ADDENDUM #1

Date:	July 16, 2008
To:	Contractors
From:	Tim Parkinson, Project Manager, DFCM
Reference:	Chiller Replacement Ogden Weber ATC – Metals Bldg. – Ogden, Utah DFCM Project No. 08049240
Subject:	**Addendum No. 1**

ADDENDUM #1

RE: DFCM Project # 08049240
Ogden Weber Applied Technology College Chiller Replacement

Dimensions – Six Fan Units

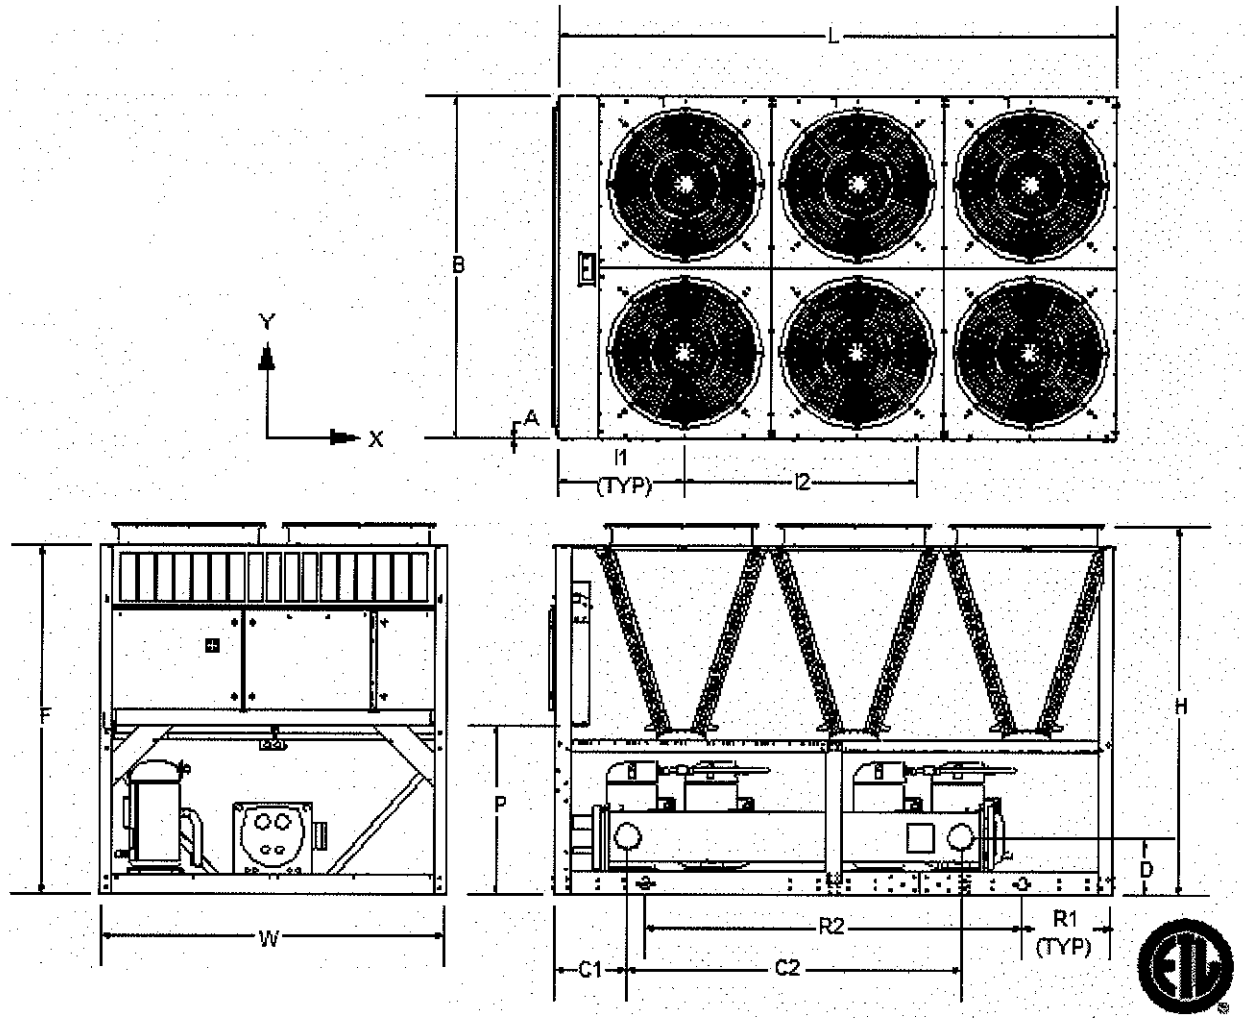
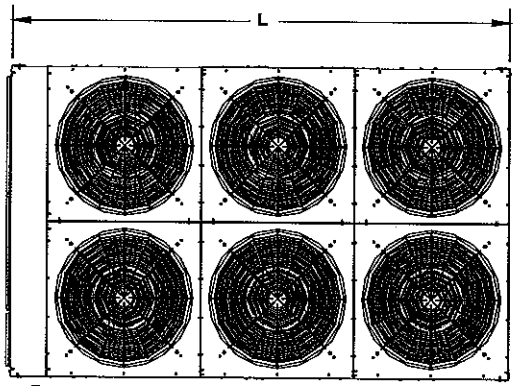
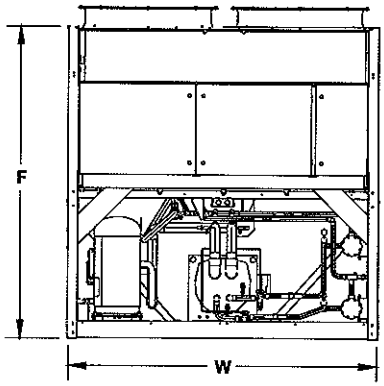
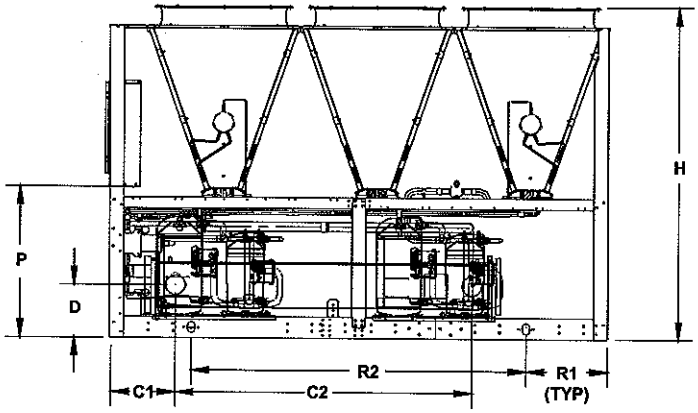
ITEM #3 – New chiller information is attached showing footprint and specified information. SEE ATTACHMENT.
